COOPER NUCLEAR STATION

AMENDMENT TO FACILITY OPERATING LICENSE

Amendment No. 8
License No. DPR-46

CHANGE NO. 11 TO THE TECHNICAL SPECIFICATIONS

**FIGURE 3.5.1 MAXIMUM ALLOWABLE
AVERAGE PLANAR LHGR**

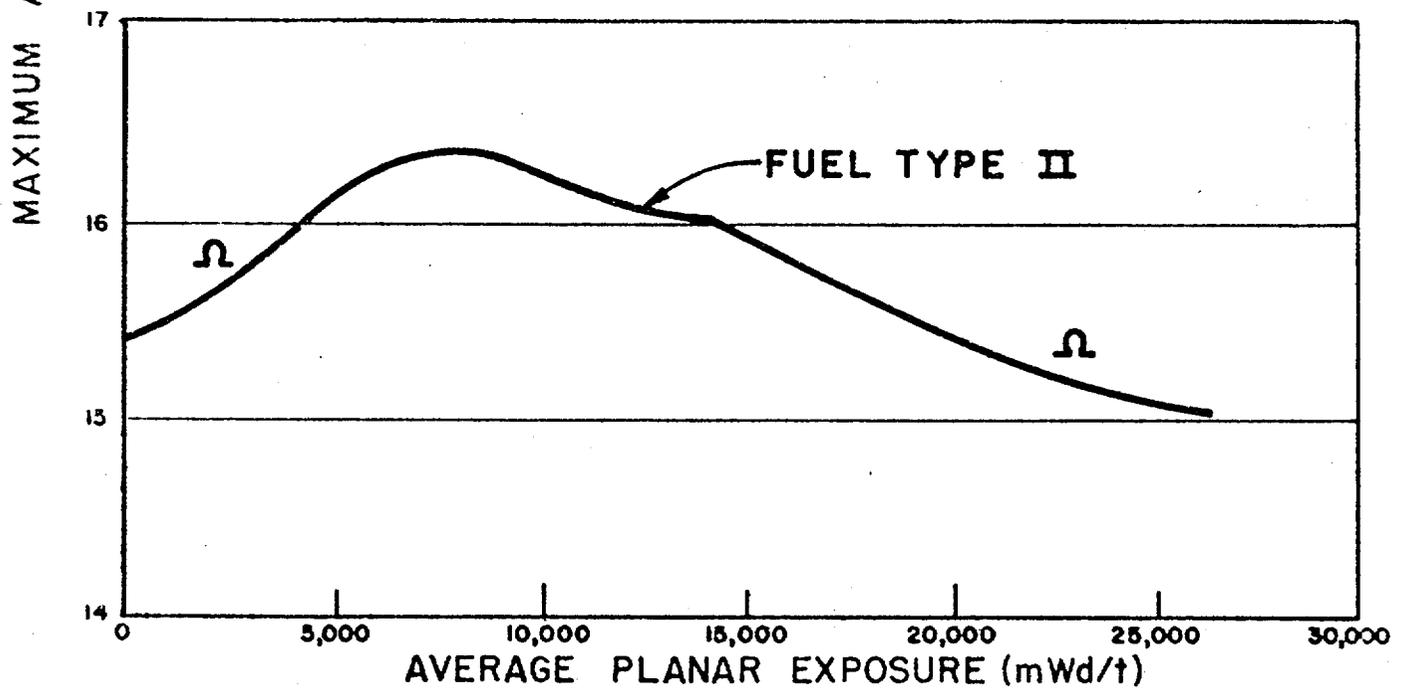
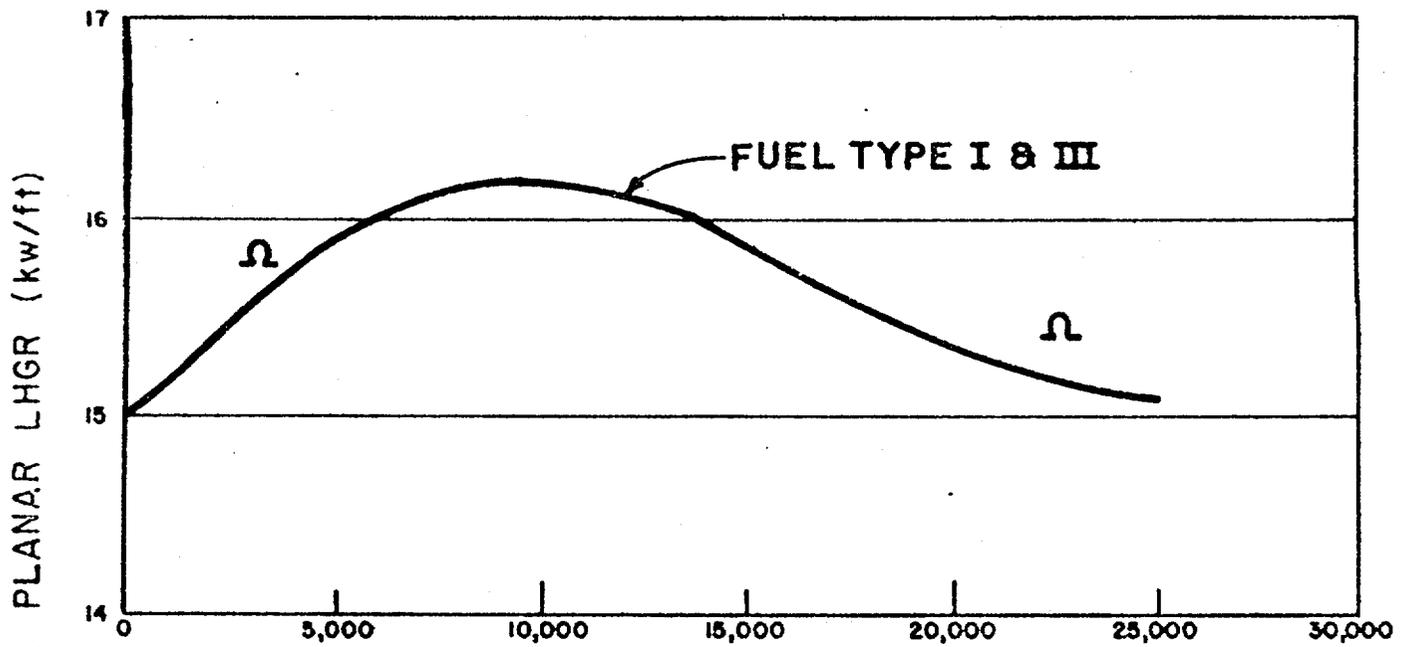
The amendment permits an increase in the maximum average planar linear heat generation rate curves.

During steady state power operations, the average linear heat generation rate (LHGR) of all the rods in any fuel assembly, as a function of the average planar exposure, at any axial location, shall not exceed the maximum average LHGR shown in Figure 3.5.1

11 | The maximum average planar LHGR's shown in Figure 3.5.1 are based on calculations employing the models described in the General Electric Report NEDM-10735 as modified by General Electric Report NEDO-20181, which was modified by the Regulatory staff in "Supplement to the Technical Report on Densification of General Electric Reactor Fuels, December 14, 1973".
